SUBURBAN COLLECTION SHOWPLACE EXPANSION JSP16-12

Public Hearing at the request of TBON, LLC for Planning Commission's recommendation to City Council for approval of Special Land Use, Preliminary Site Plan, Wetlands Permit and Stormwater Management Plan. The request is for an expansion of the building and parking lot for land within the OST, Planned Office Service Technology District, and in the OST, Planned Office Service Technology District with an EXO, Exposition Overlay District. The subject property is located in section 16, north of Grand River Avenue and west of Taft Road. The applicant is proposing to expand the existing showplace exposition facility by adding a 175,815 square foot building addition, with associated parking lot and other site improvements. The site plan is proposing an off-street parking lot on an adjacent OST-zoned property to serve the exposition facility. Off-street parking lots on another site require a Special Land Use Permit.

PLAN REVIEW CENTER REPORT

Planning Review

SITE PLAN

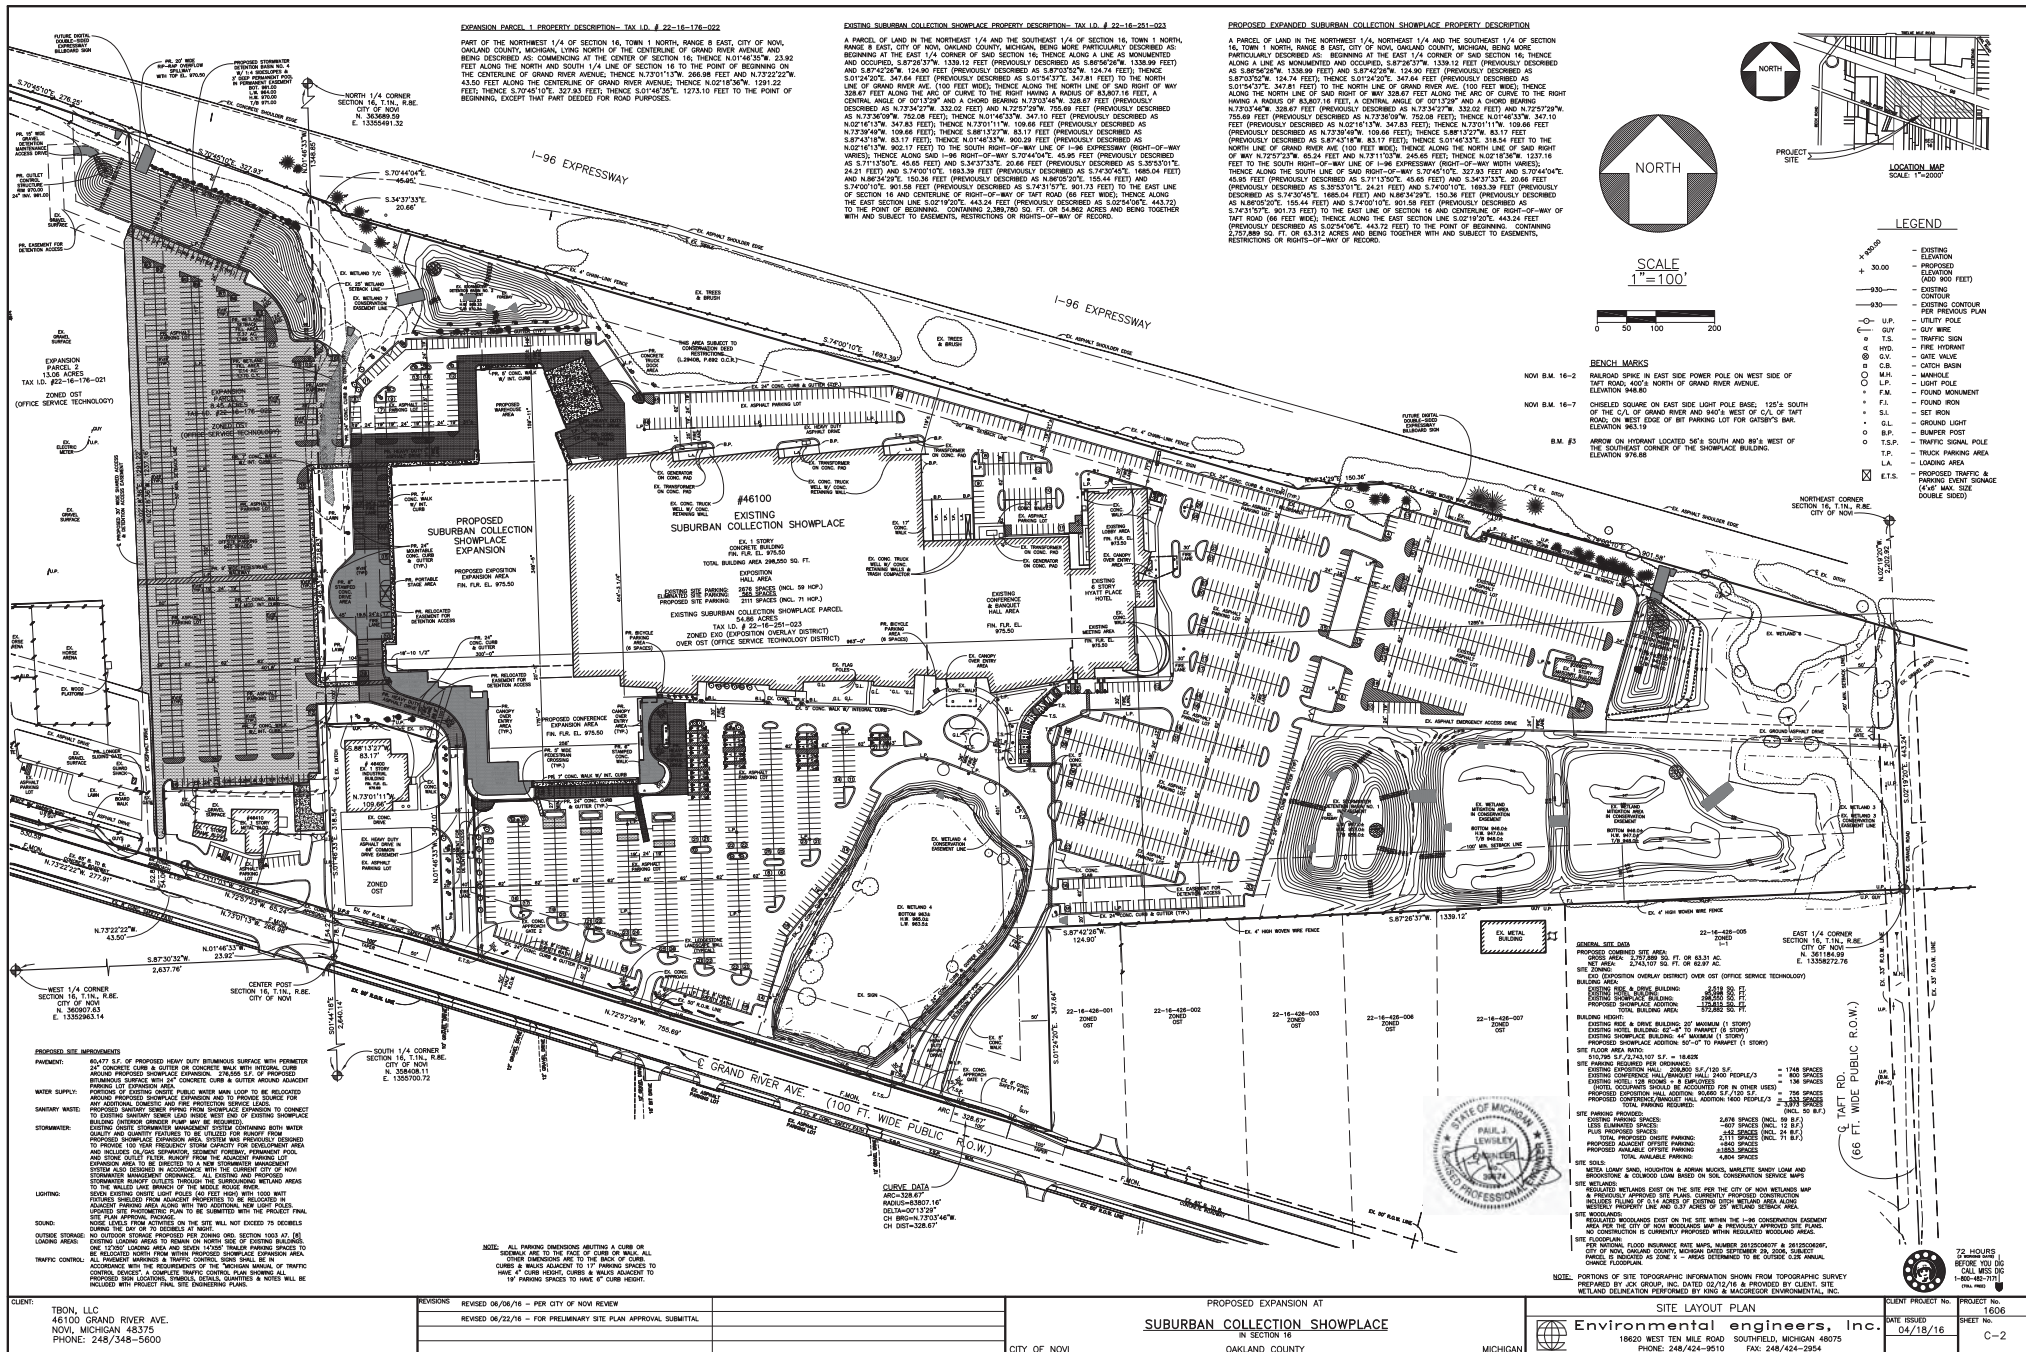
paved parking spaces are proposed for the new expansion, The Overall Master Site Plan, Sheet C-1 shows two additional "Expansion Parcels" to the west, but are not part of the site plan request at this time.

1. **Building Setbacks (Sec. 3.1.15.D):** Front building setbacks shall be a minimum of 100 feet for EXO zoning. The proposed site plan is deviating from the minimum required setback distance at multiple locations at the southwest corner of the addition due to the recessed natures of the building footprint. The deviations vary from 2 feet to approximately 12 feet less than the minimum, 100 feet. **The applicant can relocate or redesign the building to stay outside the setbacks or seek a variance from the Zoning Board of Appeals for the building setback deficiency.**

3. **Minimum required parking (Sec. 5.3.12):** The EXO Overlay Ordinance requires at least 75 percent of the required spaces to be provided on site subject to certain standards. A total of 2,979 parking spaces are required on site, and 2,951 spaces are provided resulting in a deficiency of 28 parking spaces. **The applicant may choose to provide updated parking calculations to include warehouse and office spaces to determine whether adequate parking is provided on site, or apply for a Zoning Board of Appeals variance for this deviation from Section 5.2.12.C.**

5. **Minimum distance between building and Off-Street parking (Section 5.2.3.):** Off-street parking for other than residential use shall be either on the same parcel of land or within three-hundred (300) feet of the building it is intended to serve, measured along a pedestrian walkway from the nearest point of such building to the nearest point of the off-street parking lot. The current plan indicates separate parcels, and provides a distance of minimum of 450

3. **Vehicular Access (Sec. 3.25.2.A):** Traffic review letter raises concerns **westerly driveway off of Grand River Avenue. The applicant is asked to provide additional information as requested so that a proper determination with regards to the need for a new taper lane on Grand River Avenue at the westerly driveway. Refer to Traffic review for further details.**

4. **Pedestrian Ways:** The ordinance requires the submitted site plan to show pedestrian sidewalks within an exposition conference and convention facility site to permit safe and convenient access to the facility from parking lots and adjacent properties. Staff notes that the applicant has proposed one pathway connecting the proposed westerly off-

street parking lot with the proposed building addition. **Staff recommends the applicant to continue to consider additional means to assure safe and convenient access such as wayfinding, raised landscaped islands to buffer the pathway, or other means. The pathway should be extended to the building to provide direct access to the entrances.**

5. Barrier free parking: **Barrier free spaces shall be distributed among all building entrances according to the Building Code. Provide some handicap accessible spaces near the proposed building entrance on west.**

POURED CONCRETE WALL SYSTEM	8,659 SQ. FT.	9%
HORIZONTAL METAL PANELS A	1,837 SQ. FT.	2%
HORIZONTAL METAL PANELS B	4,473 SQ. FT.	6%
VERTICAL METAL PANELS	32,148 SQ. FT.	43%
SPLIT-FACE CHU	20,640 SQ. FT.	28%
ANOD. ALUM. GLAZING	8,655 SQ. FT.	13%
BUILDING TOTAL	74,383 SQ. FT.	100%

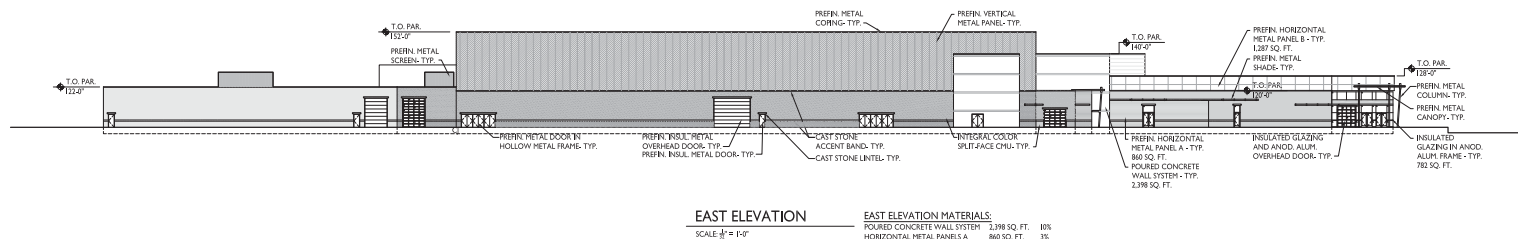
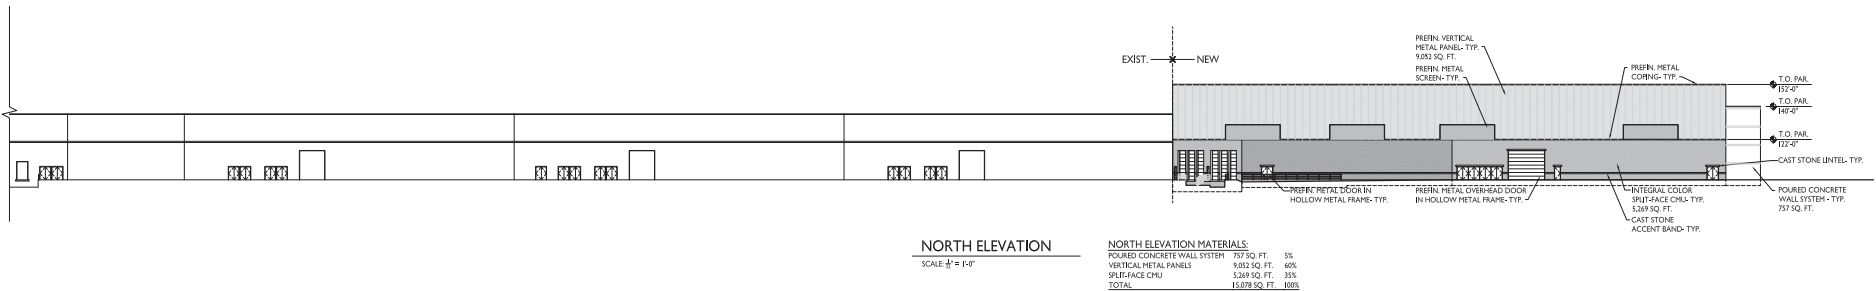
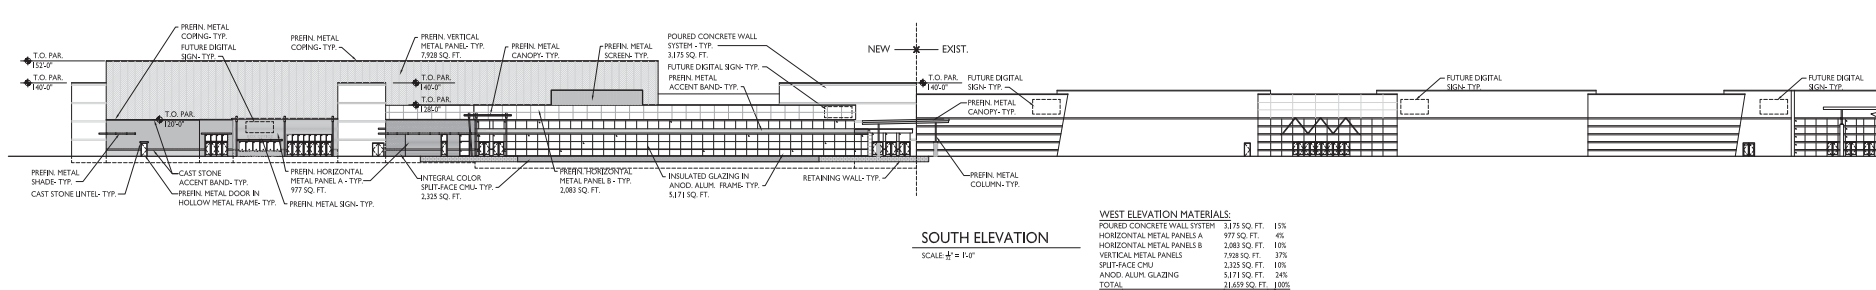
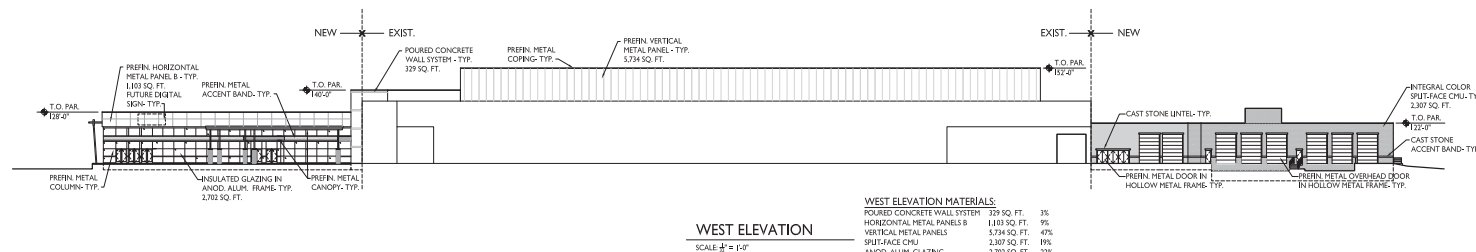
- a. A section 9 façade waiver for the overage of Horizontal Rib Metal Panels(0% allowed, a maximum 15% on south, 5% on North, 3% on east and 8% on west provided), Vertical Metal Panels(50% allowed, 60% on north and east side provided) and Split Faced CMU(10% allowed, 15% on south, 35% on North, 24% on east and 43% on west provided);
- b. Applicant shall plant additional trees to address staff's comments with regards to Landscape screening requirements adjacent to I-96 right of way as determined by the City's Landscape Architect during a site visit after the installation of transplanted trees ;
- c. A Landscape waiver to permit the absence of required landscaped area within the parking lot (approximately 15,664 sf is required, 0 provided), as listed in Section 5.5.3.C.iii ;
